Access Compliance Report Public Rights-of-Way (Pedestrian Signals)

Main Street: **E_FAIRHAVEN_AVE** Cross Street: **ETON_PL** Location: **SE**

ADA ID: **SGRK211007110348** Signal Type: **One Push Button-Non APS** Overall Compliance: **No** Severity Scores: **BTN 1: 35** **BTN 2: N/A** **No BTN: N/A**

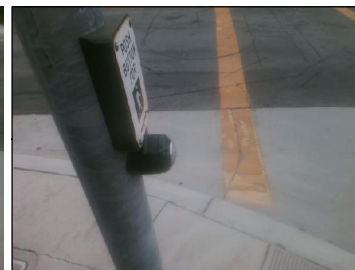
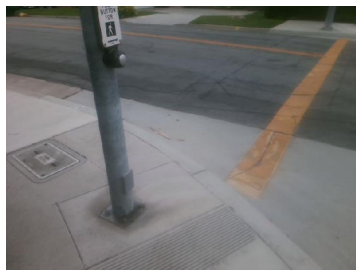
OC Std/PROW: **R404.2, MUTCD 4e.08**

Possible Solutions: Replace Signal Push Button With APS Button. Remove and Replace Clear Space.
